MARA ROAD EXTENSION

ADDENDUM #1

JANUARY 5, 2023

THRASHER PROJECT #101-T30-11030

DRIVE PROFILES
 MARA ROAD

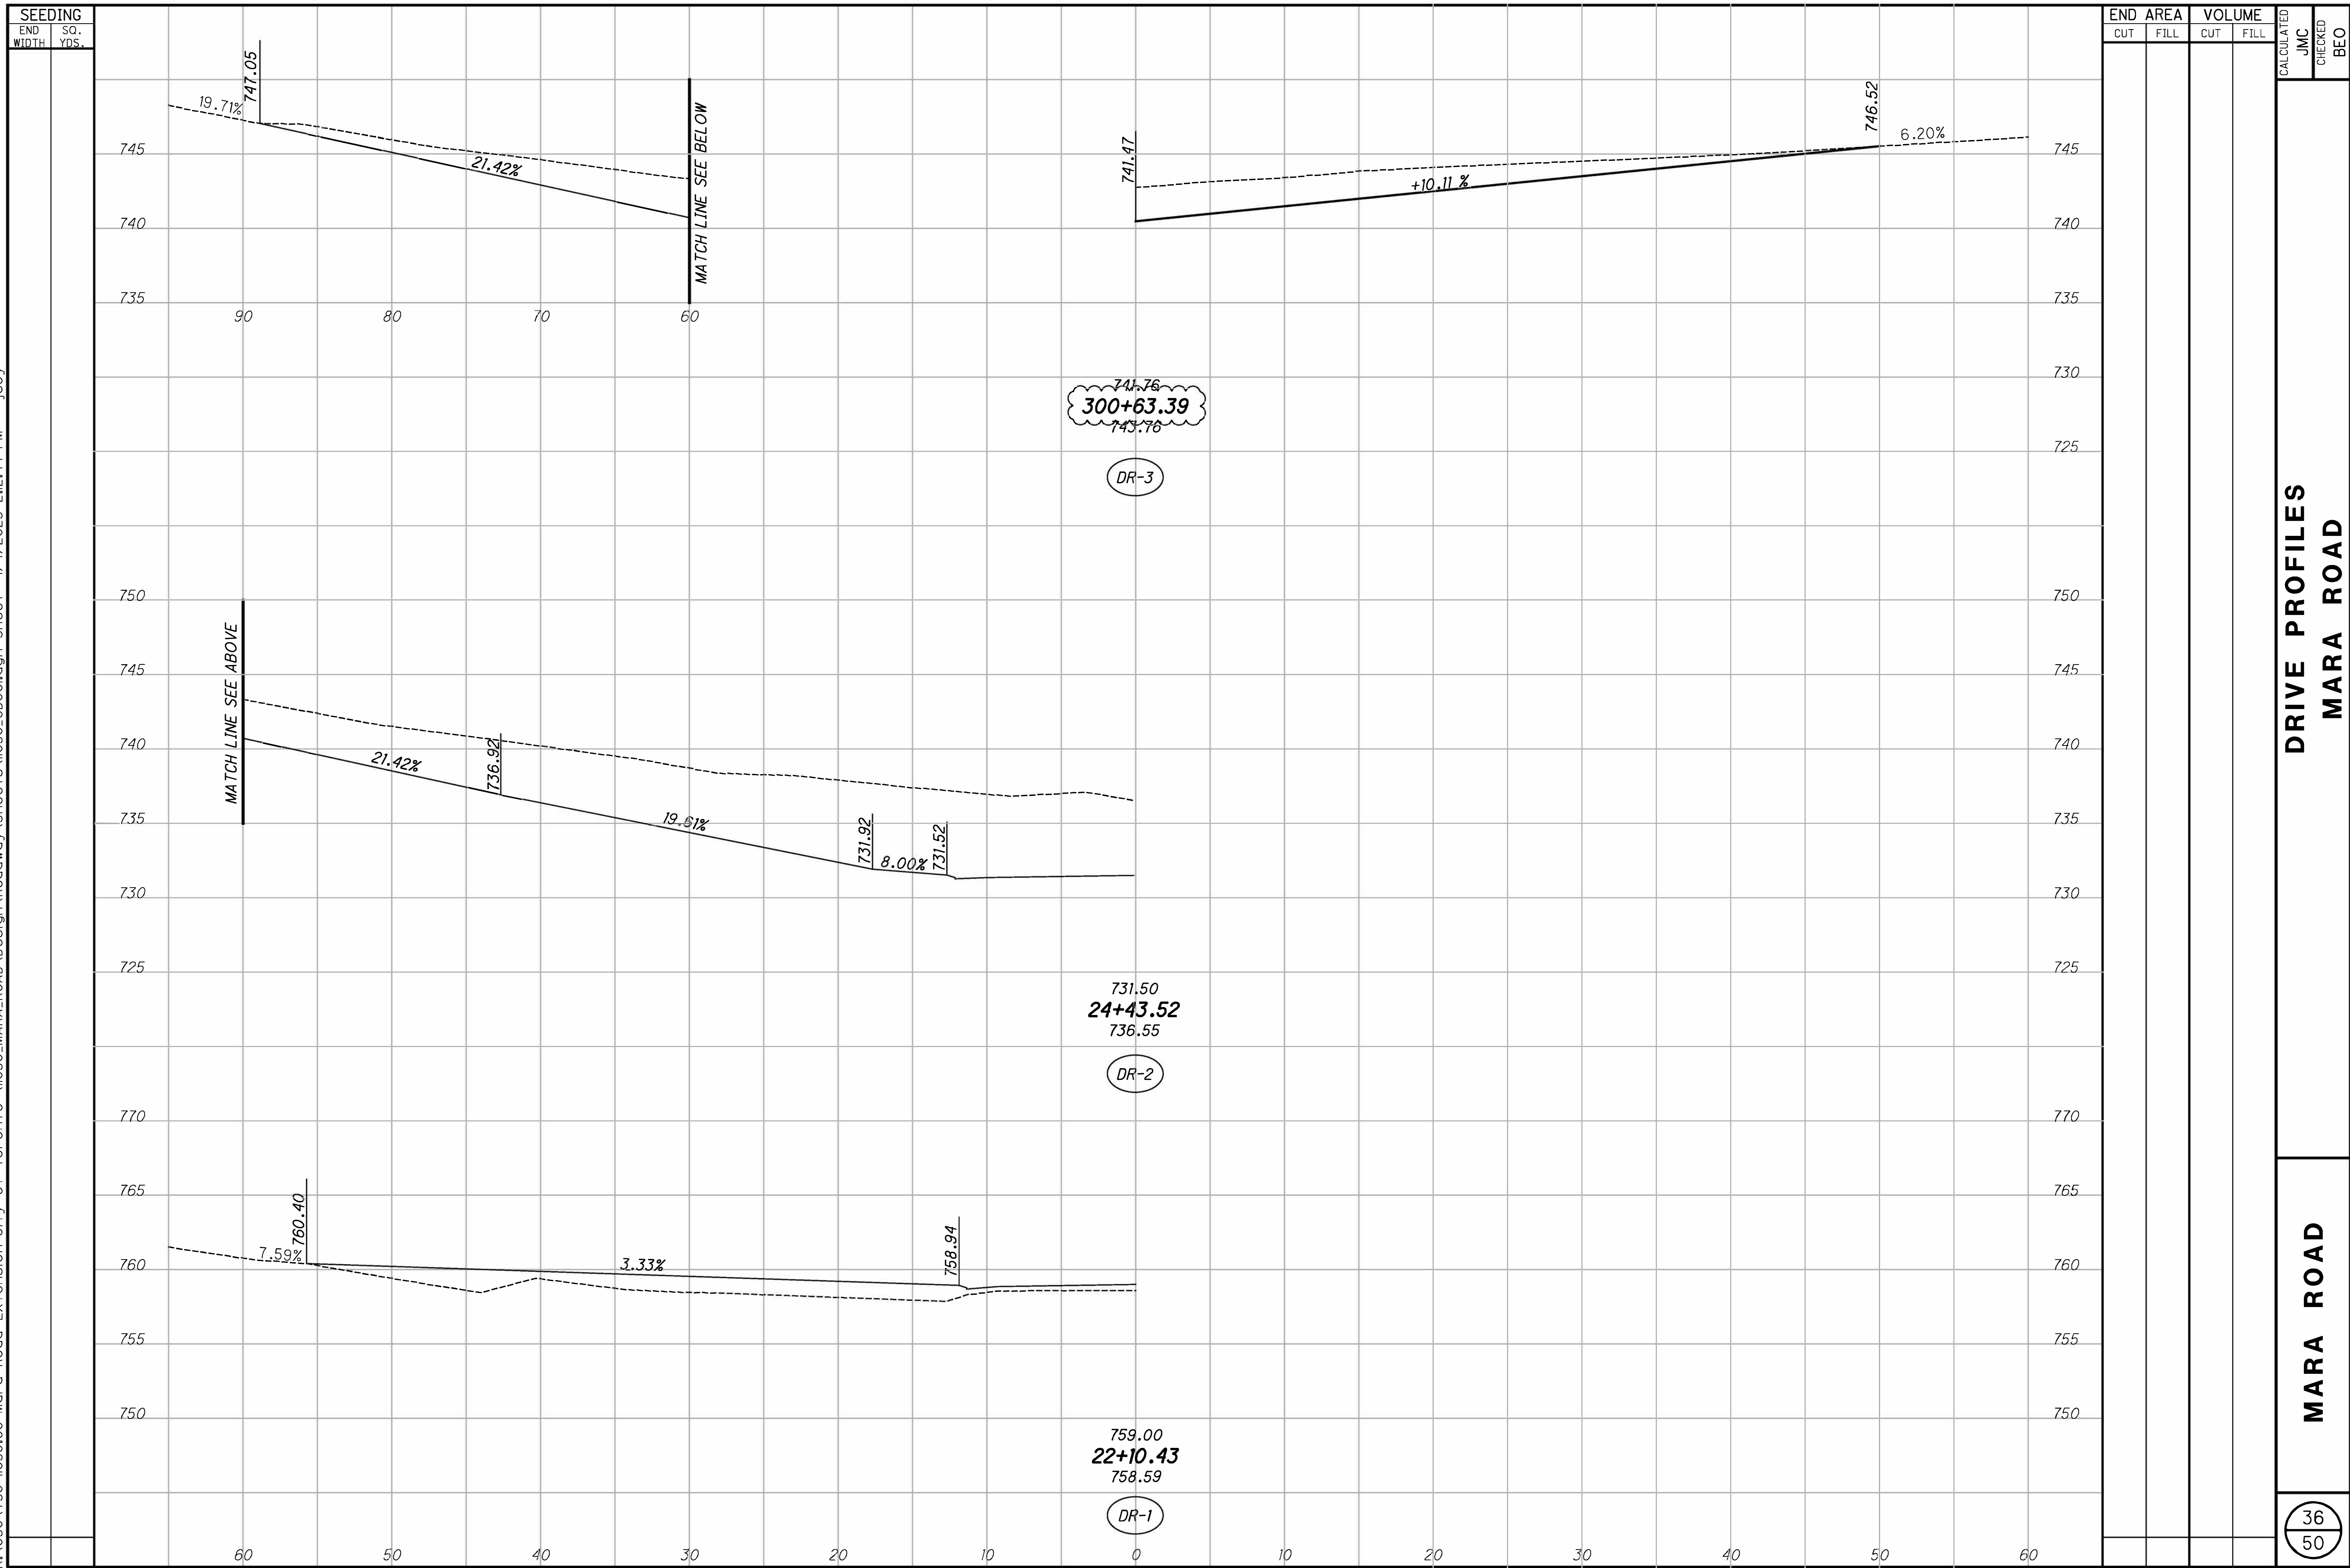
43. *Sht 36/50, DR2 & DR3 indicate cut to reconstruct the driveways, but the plans do not indicate any cut slopes. Are these to be constructed without any slopes?*

Drives are to be constructed per the drive profiles on sheet 36 and shoulders graded to tie into existing.
